Re: The Reno Rail Corridor, Reno, Nevada
MRCE File No. 9432

In accordance with our agreement of August 24, 2000 MRCE has completed its review of the proposed Reno Rail Corridor project which proposes the below grade depression of the Union Pacific railroad tracks which pass through the center of the City of Reno.

MRCE's scope of services is limited to the review of the diaphragm wall alternative for the construction of the below grade structure, including a review of the project documents and details, the provision of slurry walls specifications and recommendations on construction and an estimate of wall seepage at a typical cross section of the structure.

D-1

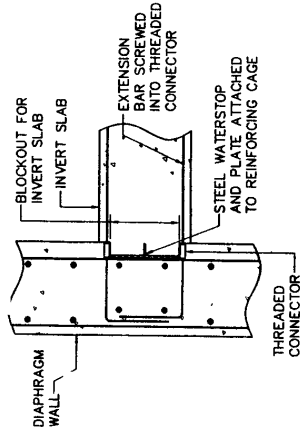
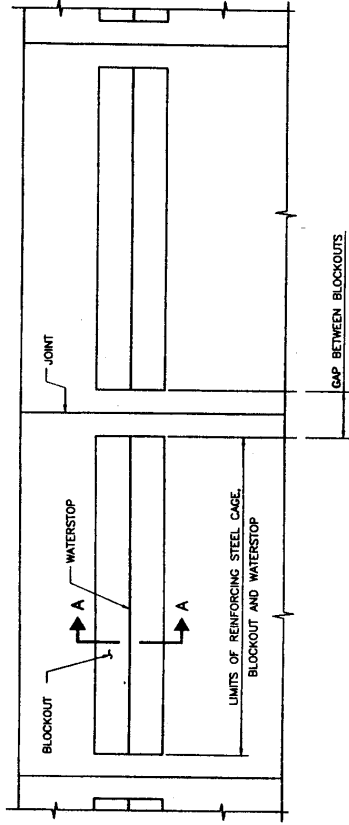
We have prepared Drawing No. D-1, attached, showing a diaphragm wall construction with struts and a jet grout plug. We used this drawing as our base line for estimating leakage into the site during construction and into the finished structure upon completion of construction. We have performed preliminary checks of the buoyancy of the structure during construction and as a completed structure. We believe that a 14 foot thick jet grouted soil plug (from the base of the invert slab downward) would provide a suitable plug for sealing the excavation during construction at the deepest section of the structure. We are showing a partial embedment of the diaphragm wall below the finished invert slab. The depth of embedment is to be determined through structural design and considerations of leakage between the jet grout plug and the diaphragm wall. We have also determined that an approximate 6 foot thick reinforced concrete invert slab would be sufficient to resist buoyancy after completion of the construction. The impermeability of the invert slab could be significantly improved with a waterproofing membrane. The 6 foot invert slab dimension should be verified during structural design. We have also assumed a 3 foot thick reinforced concrete diaphragm wall is adequate for structural purposes. For our seepage analysis, we have assumed ground water is 22 foot below existing grade indicated on your documents.

For the temporary condition during construction, we have estimated seepage through the diaphragm wall panel, through the jet grout plug, through the joint between the jet grout plug and through the diaphragm wall. For this temporary condition, at the deepest section of the project, we estimate a maximum seepage of 4,000 gallons per day per 100 foot of structure, and a minimum seepage of 300 gallons per day per 100 foot of structure. About half that seepage is expected through the jet grout plug. If the higher rate of seepage occurs, it may last for several days or weeks during the period of time that the contractor is searching for the source of the leak and making repairs.

For the permanent condition, we have estimated seepage through the diaphragm wall panels, seepage through the invert slab (with and without waterproofing) and seepage through the joint between the invert slab and the diaphragm wall. Our estimate of maximum seepage is 50 gallons per day for 100 foot of structure with no membrane provided below the invert slab and 10 gallons per day with a membrane waterproofing provided below the invert slab. For this seepage estimate we have assumed that the transverse construction joint in the base slab is properly "water stopped" and that a third of the seepage occurs at the panel joint and at the wall/base slab joint.
